**Marion County  
Board of County Commissioners**

**PLANNING & ZONING SECTION  
STAFF REPORT**

<b>Public Hearing Dates</b>	<b>P&amp;Z: 5/28/2025</b> <b>Continued from 3/31/2025 after</b> <b>being continued from 1/27/2025</b>	<b>BCC: 6/16/2025</b>
<b>Case Number</b>	250204SU	
<b>CDP-AR No.</b>	32615	
<b>Type of Case: Special Use Permit</b>	Utility company service yard including office building, warehouse, and outdoor equipment and material storage "lay-down yard."	
<b>Owner</b>	<b>SECO Energy</b> / Sumter Electric Cooperative, Inc. (previously Southern Hills Limited, Inc., Nan P. Bonfield, and Bryan Laura Trust)	
<b>Applicant</b>	Victoria Diaz, Bowman	
<b>Street Address</b>	12644, 12830, and 12940 SW 16 <sup>th</sup> Avenue	
<b>Parcel Number</b>	41200-012-00, 41200-020-00, and 41200-020-01	
<b>Property Size</b>	±39.20, ±20.00, and ±20.00 acres, totaling ±79.20 acres	
<b>Future Land Use</b>	Employment Center (EC)	
<b>Zoning Classification</b>	Community Business (B-2) [Based on an approval for Zoning Case No. 250203ZC representing ±39.20 acres of the ±79.20-acre site.]

**Figure 6**  
**Concept - Site Plan**

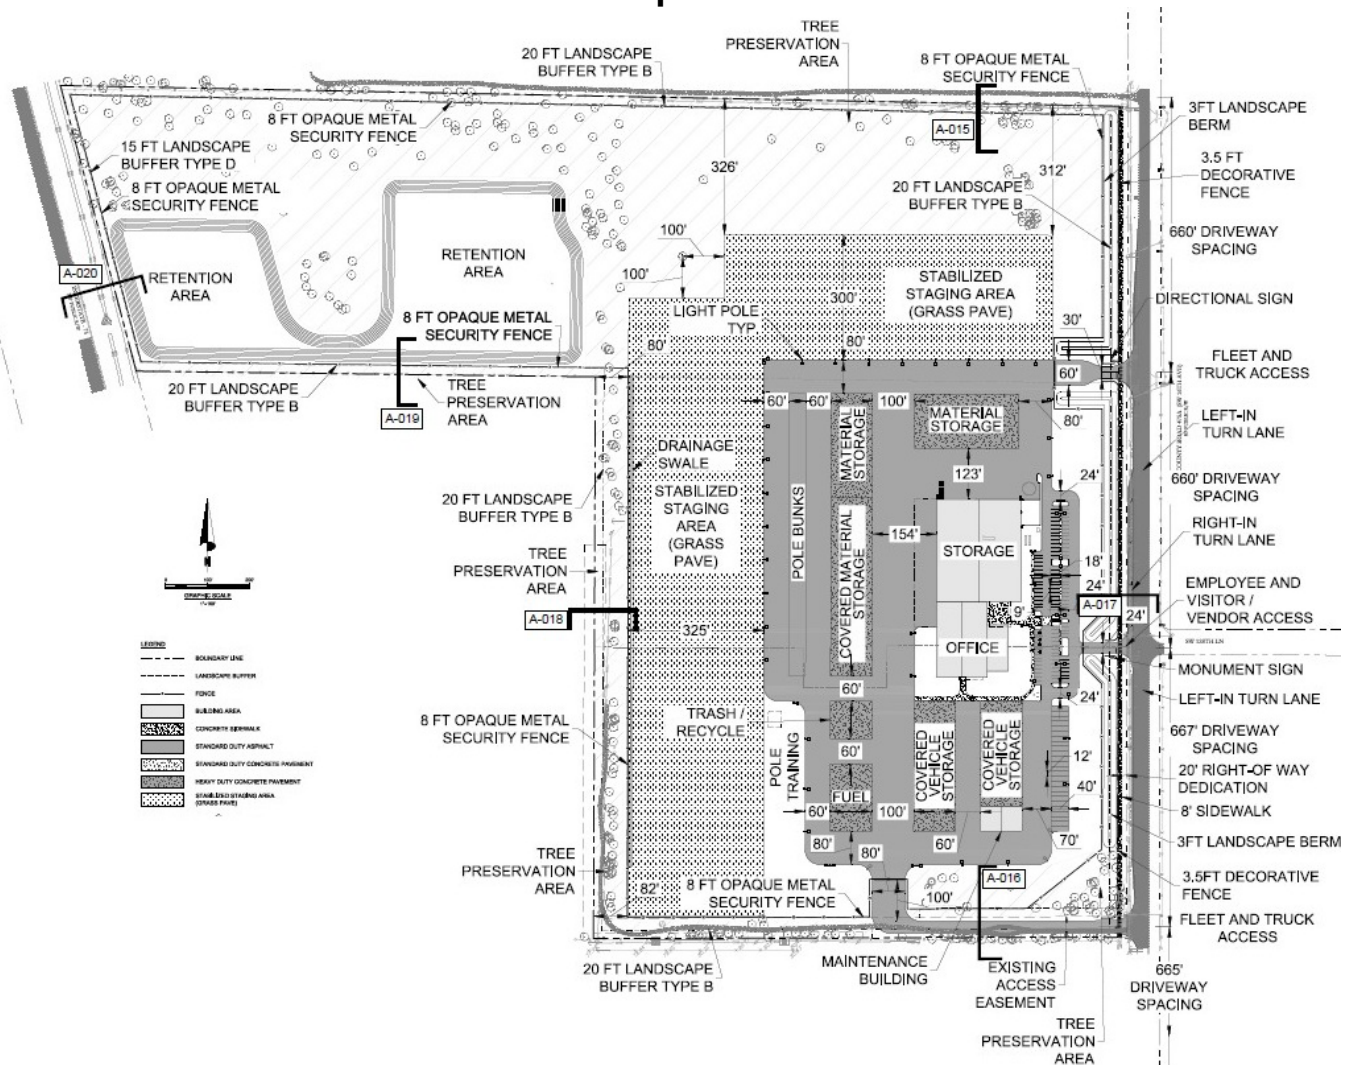
An office building with storage warehouse will be in the center of the southern 2/3 of the site. Paved areas will then be provided north, south, and west of the building where covered vehicle storage areas will be south while combinations of covered and open material storage will be west and north. Stabilized grass paved staging/storage areas will

then be located to the west and north of the paved areas; the findings indicate these grass paved areas will be used for overflow parking during emergency responses. The grass paved areas to the west will extend to that area's west boundary while the grass paved area to the north will be separated from the site's north boundary by 312-foot wide "open space area" including the site proposed buffer. The western portion of the site's north parcel will serve as the stormwater drainage retention area (DRA), with the open space along the north boundary extending west to I-75, that will support maintaining existing trees along the north portion of the site. Public and employee parking areas will be located primarily between the office/warehouse and covered parking areas and CR 475A.

Three site access points are proposed. One employee and visitor/vendor access will be provided in the general center of the site with a driveway access point that aligns with SW 128<sup>th</sup> Lane. Fleet & truck entrances will be provided at the north and south ends of the facility. The south fleet & truck access point will incorporate the existing SW 130<sup>th</sup> Street Road access alignment and continue to provide access to the set of historic parcels south/west of the site. Vehicles accessing the site will turn off the improved SW 130<sup>th</sup> Street Road to enter the site through a gated entrance, while traffic for the historic parcels will then continue west.

The concept plan illustrates various parking areas and covered parking structures, along with sizeable on-site vehicle aisles that will be provided to support SECO vehicles and the necessary movements of products and materials around the "lay-down" yard. The concept plan notes the opaque 8-foot high security fencing, proposed in lieu of a wall, will also serve to control site access, and the placement of gates will need to comply with LDC requirements to ensure vehicles do not obstruct CR 475A traffic when queuing at the gates as well as providing for emergency access for emergency services. As previously noted, the preliminary Traffic Study indicates turn-lane improvements will be required at the access points, that may also serve to address queuing concerns.

7. The proposed office, warehouse, and covered vehicle parking shall be placed consistent with the SUP Conceptual Plan Set wherein the office aligns with the site's central access aligning with SE 128<sup>th</sup> Lane (identified as "Employee and Visitor/Vendor Access") and shall be designed and constructed in a manner consistent with the following standards:

- a) The office and warehouse shall be a single structure with varied vertical elevations consistent with the Community Business (B-2) Zoning height

- standards, and present visually as a fully enclosed structure with no bay doors or loading docks visible to CR 475A; and
- b) The office and warehouse shall not be a metal/corrugated siding or similar industrial appearance and shall present a façade varied in depth and finish in to avoid presenting a uniform monolithic appearance to CR 475A.

**Figure 7**  
**Concept – Landscape Plan**

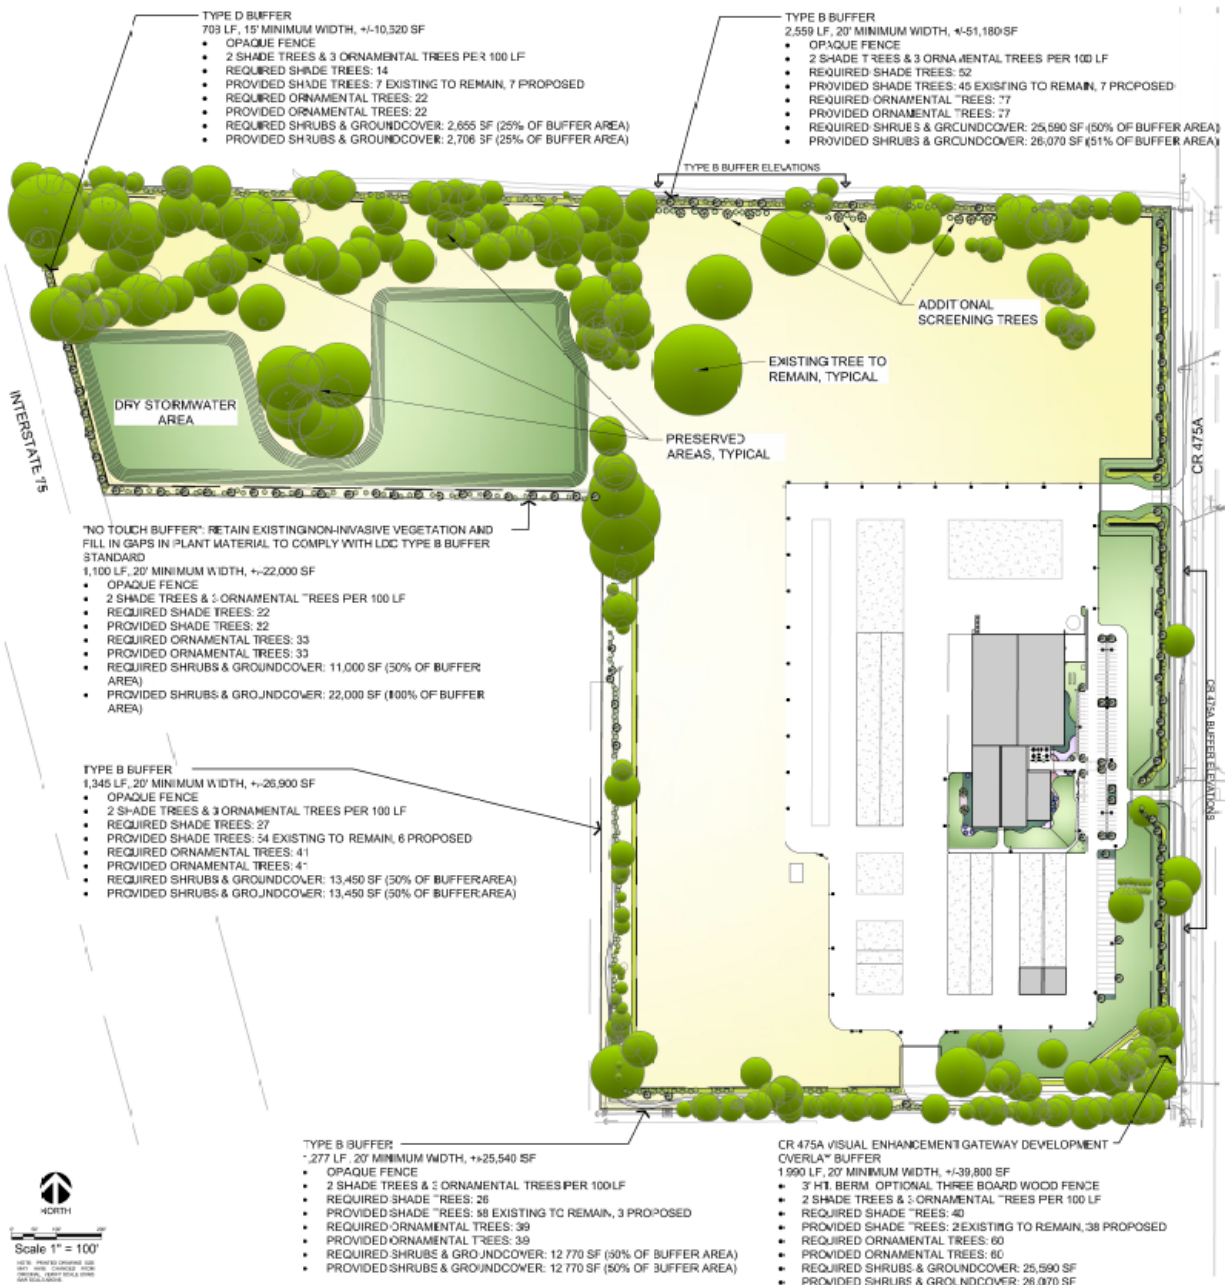
The submitted Concept Landscape Plan proposes a series of buffers along the site's boundaries based on the adjoining uses. The buffers are illustrated on the general site plan and landscape plan, with the site plan providing cross-section markers that reference the page numbers in the aerial & buffer exhibit that illustrate the buffers.

Along CR 475A, a berm topped with the required Type "C" Buffer, widened to 20-feet rather than 15-feet as required by the CR 475A Overlay, is indicated. The plan notes the provision of 3-foot high decorative board fence within the buffer as supported by the CR 475A Overlay; further, an 8-foot high opaque metal fence with green metal and trim finish is proposed on the far internal side of the CR 475A buffer, and that same opaque fence will extend around the full site.

The immediately adjoining properties to the north, and the isolated properties to the south/west, are either developed with single-family homes and/or in agricultural use with General Agriculture (A-1) zoning. Commercial use of the site is required to provide a B-Type Buffer to single-family uses and a D-Type Buffer to agricultural uses; both the B-Type and D-Type Buffers require the provision of a minimum 6-foot high wall along the interior side of the buffer. *In lieu of the required wall, the plan proposes the noted 8-foot high opaque metal fence with green metal and trim finish for the buffer walls.* The buffer requirements for each boundary are summarized below, wherein compliance with the applicable design standards is proposed, except for the noted replacement of the required wall with the *8-foot high opaque metal fence*:

- 1) North boundary - 20-foot wide B-Type Buffer; *however, the plan proposes an opaque security fence in lieu of a wall*, along with an area of open space approximately 300-feet in depth south of the buffer.

- 2) West boundary shared with I-75 (north parcel of the site) - 15-foot wide D-Type Buffer; *however, the plan proposes an opaque security fence in lieu of a wall against the planned DRA.*

- 3) South boundary (north parcel of the site) - 20-foot wide B-Type "No Touch Buffer" with vegetation added to meet the Type "B" Buffer vegetation standards; *however, the plan proposes an opaque security fence in lieu of a wall against the proposed DRA.*

- 4) South boundary (corresponds to SW 130<sup>th</sup> Street Road) - 20-foot B-Type Buffer; *however, the plan proposes an opaque security fence in lieu of a wall.*

- 5) West boundary (north project of SW 130th Street Road shared with the isolated parcels) - 20-foot wide B-Type "B" Buffer; *however, the plan proposes an opaque security fence in lieu of a wall.* Staff notes that for this boundary location, the site is expected to be elevated above the existing off-site grade levels, so the site and the outside equipment and materials storage will be "above" the adjoining residential properties to the west. Currently, that shared boundary features limited vegetation, and while plantings will be provided, lighting from that area is a concern due to its elevated position. *The applicant has proposed that all site lighting will comply with LDC Division 6.19 - Outdoor Lighting, and has agreed to comply with "Dark Sky" principles in response to Attorney Batsel's March 29th letter.*

4. All buffers and boundaries shall include those improvements depicted or noted on the SUP Conceptual Plan Set and accompanying documents and complying with the following:

- c) The site shall include the 8-foot opaque security fencing and gates, as shown in the SUP Conceptual Plan Set, that shall be provided around the entire property as indicated,

- d) B-Type Buffers shall consist of a 20-foot landscaped strip and an eight-foot (8') opaque security fence. The landscaped strip shall contain at least three shade trees and five accent / ornamental trees for every 100 lineal feet or fractional part thereof. Shrubs and groundcovers, excluding turfgrass, shall comprise at least 50 percent of the required buffer area and shall form a layered landscape screen with a minimum height of three feet within one year of planting.

- e) The B-Type Buffer along the west side of subject property's two southern parcels, adjoining off-site PID#s 41200-011-00, 41200-023-00, and 41200-024-00, shall be provided as indicated, subject to the following:

- 1) At the time of planting/installation, a minimum of 1/3 of the shade trees and 1/5 of the accent/ornamental trees shall be increased in size at the time of planting to be 25% above the minimum planting size as specified by the LDC.

- 2) The 8-foot opaque fencing along this west boundary shall be installed at the outer perimeter of the outdoor storage "lay-down" yard areas as indicated in the SUP Conceptual Plan Set, and the minimum fencing height shall be based on, and measured from, the finished grade elevation of the adjoining outdoor storage "lay-down" yard areas, to screen those areas when their finished grades have been elevated in relation to the site's adjoining property lines.

- f) D-Type Buffers shall consist of a 15-foot landscaped strip and an eight-foot (8') opaque security fence. The landscaped strip shall contain at

- least three shade trees and five accent / ornamental trees for every 100 lineal feet or fractional part thereof. Shrubs and groundcovers, excluding turfgrass, shall comprise at least 25 percent of the required buffer area and shall form a layered landscape screen with a minimum height of three feet within one year of planting.

- g) CR 475A (modified C-Type) Buffer shall consist of a 20-foot landscaped strip and an eight-foot (8') opaque security fence. The landscaped strip shall contain at least two shade trees and three accent / ornamental trees for every 100 lineal feet or fractional part thereof. Shrubs and groundcovers, excluding turfgrass, shall comprise at least 50 percent of the required buffer area and shall form a layered landscape screen with a minimum height of three feet within one year of planting. In addition to the foregoing and as depicted on the SUP Conceptual Plan Set, the eastern boundary shall also include a three-foot (3') berm and decorative 3-board fence, pursuant to LDC Section 5.8.A, Figure 5.8.5-1.
